Access Compliance Report

Public Rights-of-Way

(Curb Ramps)

Intersection ID: 9858	Main Street: MERCURY_ST	Cross Street: N_DAVIDSON_ST	Location:	N
ADA ID: EA1415D70F91	Ramp Type: BlendTrans2	Initial Pass/Fail: Pass	Overall Compliance: No	Severity Score: 0

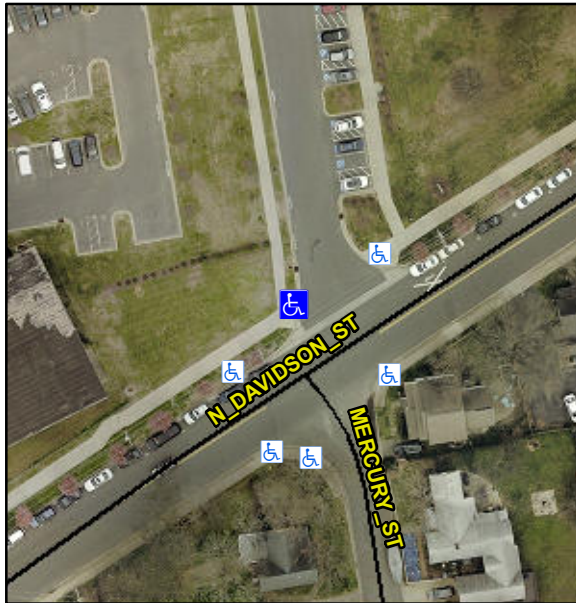
R304.2.3, R305.2

Remove & Replace Curb Ramp With Two New Directional Ramps or Equivalent.
